PIC16F1934/1936/1937 and PIC16LF1934/1936/1937 Family Silicon Errata and Data Sheet Clarification

The PIC16F1934/1936/1937 and PIC16LF1934/1936/1937 family devices that you have received conform functionally to the current Device Data Sheet (DS41364D), except for the anomalies described in this document.

Data Sheet Clarifications

FIGURE 29-3: HFINTOSC FREQUENCY ACCURACY OVER DEVICE V_{DD} AND TEMPERATURE

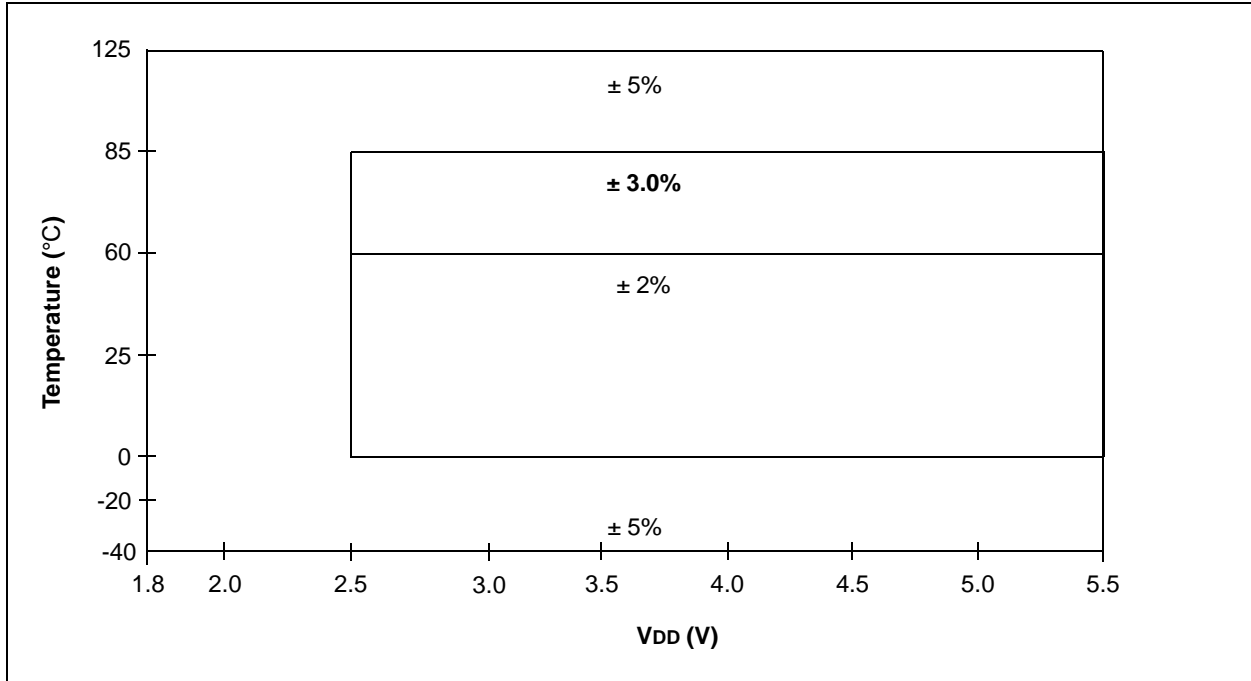
In [Figure 29-3](#), HFINTOSC Frequency Accuracy Over Device V_{DD} and Temperature, the oscillator accuracy should be $\pm 3.0\%$ when V_{DD} is equal to, and above 2.5V and when temperatures are equal to, and above 60°C, yet still equal to, or below 85°C, as shown below.
